BOARD OF ZONING APPEALS APPLICATION

Re: File No. 2-B-22-VA
1717 White Ave.

2-B-22-VA

Location: 1717 White Avenue

SECTION ALONG WHITE AVE.

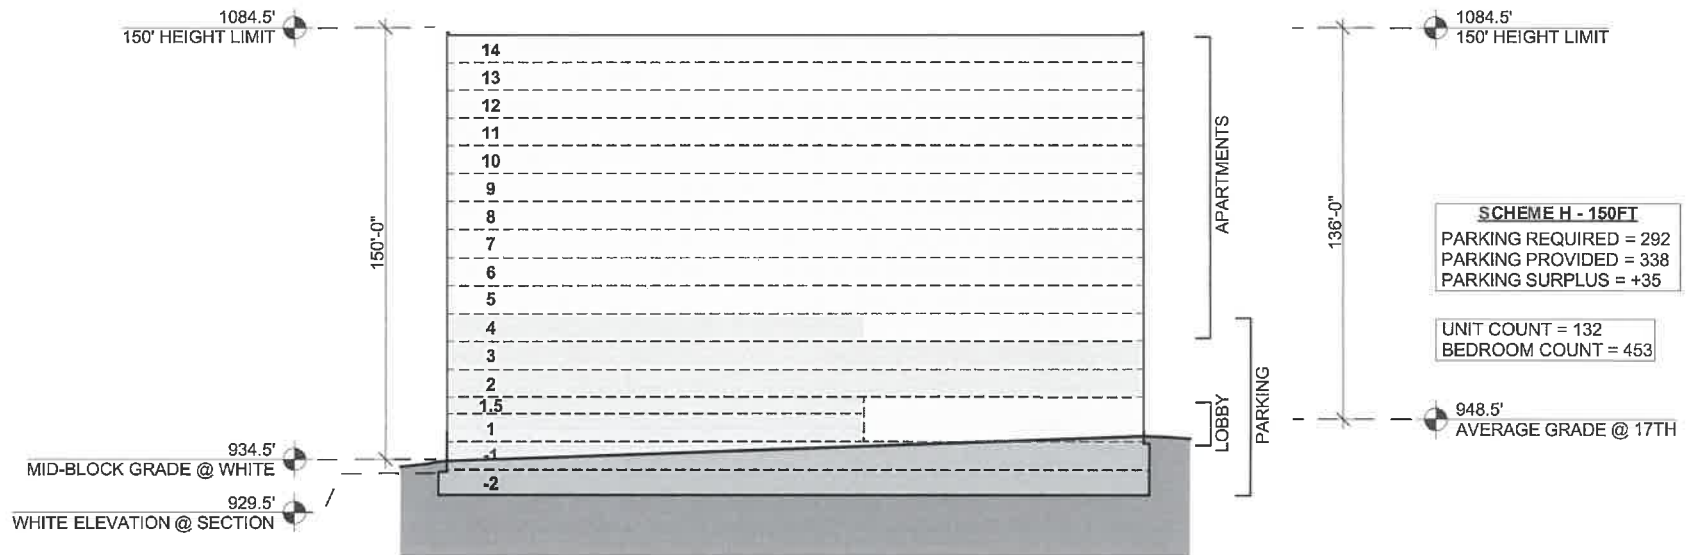
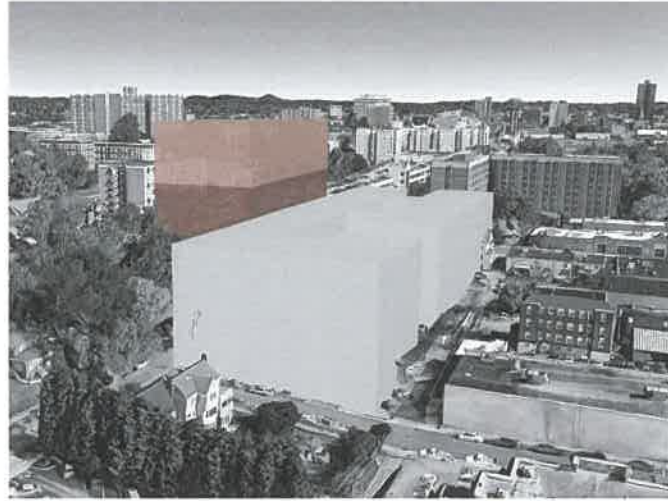
4. As can be seen in the proposed plan, a 14-story structure would significantly over tower the entire surrounding area. I can hardly imagine that this is in the interest of the neighborhood.
